**MONTGOMERY COUNTY PLANNING DEPARTMENT**  
 THE MARYLAND-NATIONAL CAPITAL PARK AND PLANNING COMMISSION

Memorandum

**SUBJECT:** Mandatory Referral No. 2011304-MCPS-1:  
 Beverly Farms Elementary School Modernization  
 8501 Postoak Road, Potomac, MD 20854  
 R-90 Zone  
 Potomac Subregion Master Plan (2002)

# Attachment 11: Traffic Queuing Plan

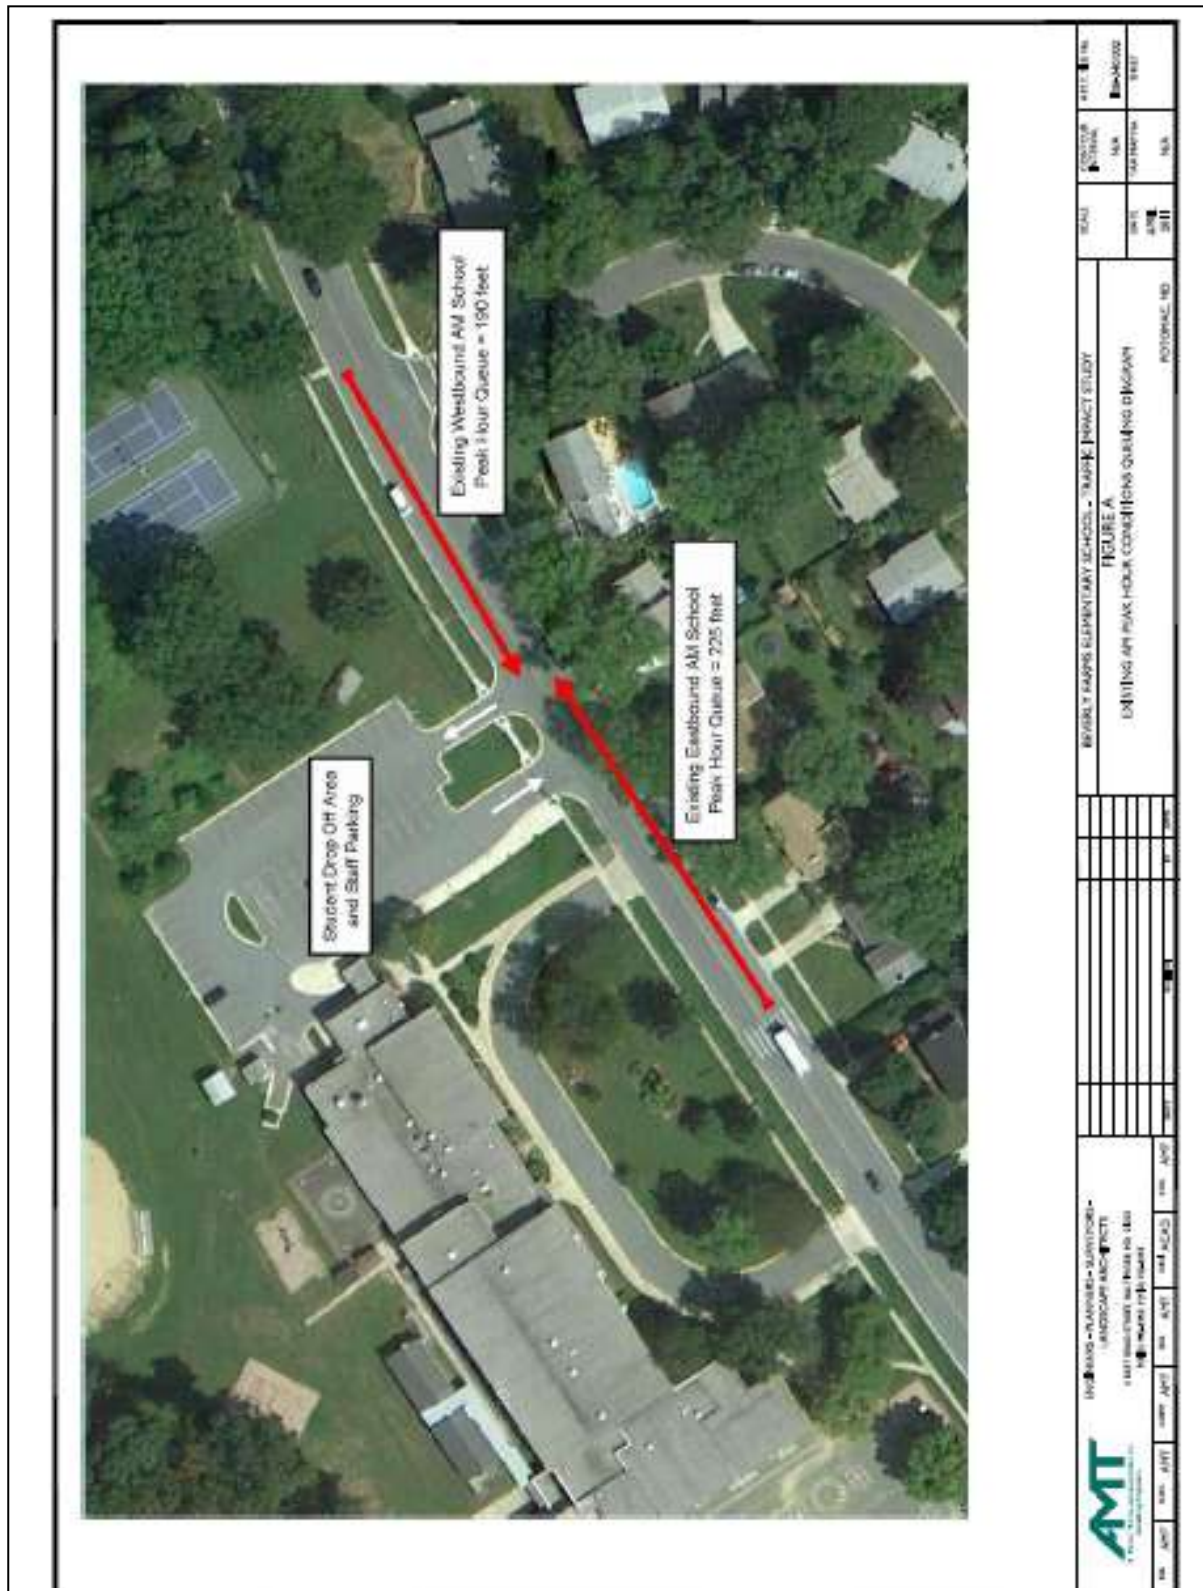
- b. MCPS must manage parent drop-off/pick-up of students entirely within the school property and must strongly discourage any drop-off/pick-up of students along Postoak Road, or any other neighboring streets.

- c. MCPS must coordinate with Montgomery County Department of Transportation (MCDOT) on site access and any need to remove parking along southbound Postoak Road (towards Tuckerman Lane) along school frontage.

ATTACHMENT A

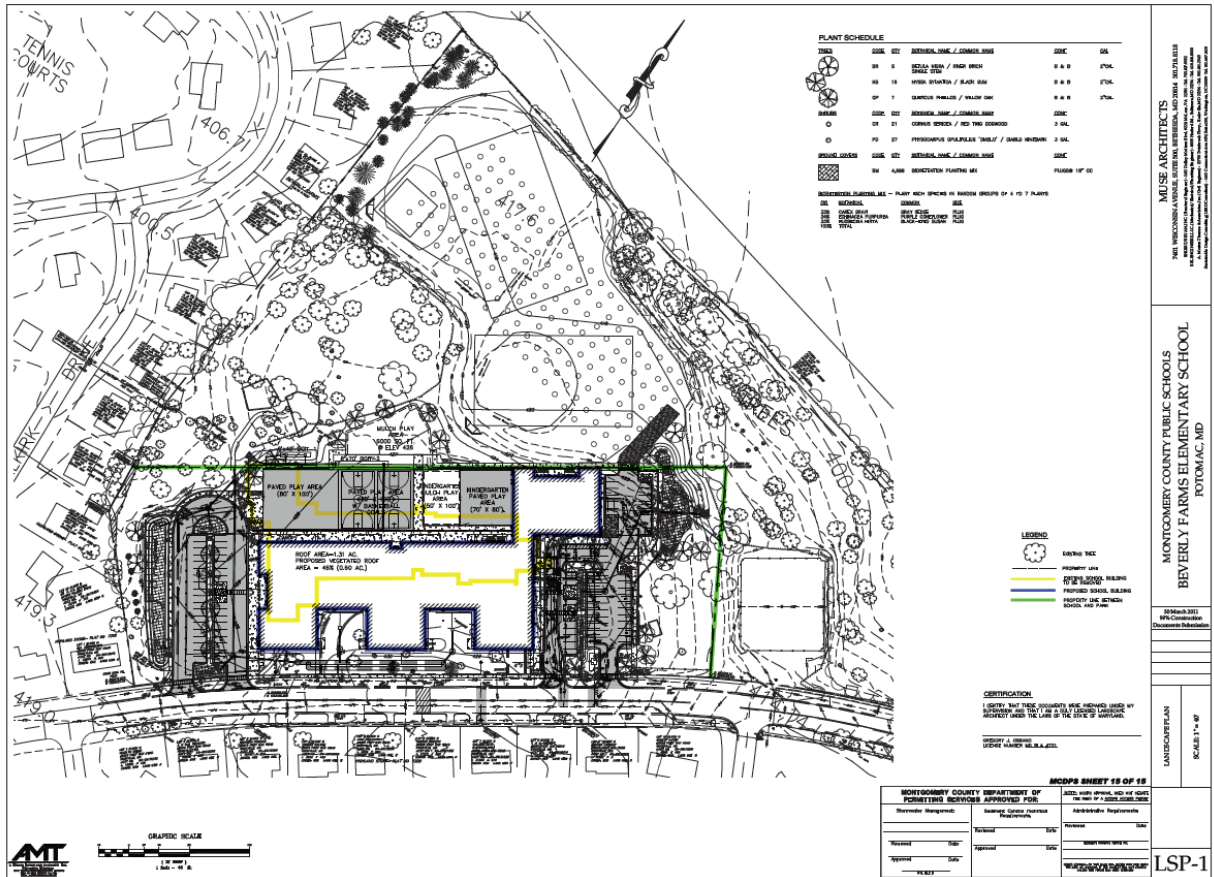
- The following events will occur during the closure period:
  1. Demolition and construction of Beverly Farms Road Elementary School,
  2. Geothermal well construction underneath current Softball Fields Number 1 and 2,

3. Reorientation of Softball Field Number 2,
  4. Backstop replacement of Softball Field Number 2 per Parks Construction Standard Details,
  5. Removal of Softball Field Number 1 backstop and skinned infield and replace with a 3-panel, 10- foot high backstop.

- Parks authorizes installation of approximately 170 geothermal heat pumps (vertical ground loop system) under current Softball Fields Numbers 1 and 2.
- Parks will require that the Park Construction Permit issuance include an easement requirement that delineates the location, and outlines maintenance and replacement responsibilities of the geothermal wells.

- Backstops and home plates are to be replaced on Softball Field Number 2. The size and specification are to be approved by the Park Manager.
- Player protection fencing and benches are to be provided at Softball Field Number 2 per specifications approved by the Park Manager.
- The infield skin will be restored at Softball Field Number 2.
- Sufficient time (i.e., one full growing season) must be provided for knitting in new turf and infield restoration before field is re-opened for permitted public use.
- Soccer Field to be restored per Department of Park's specifications.
- Grading for fields must be a 1% slope for positive drainage.
- MCPS will determine and specify whether the fields will be restored as seeded grass or sod.
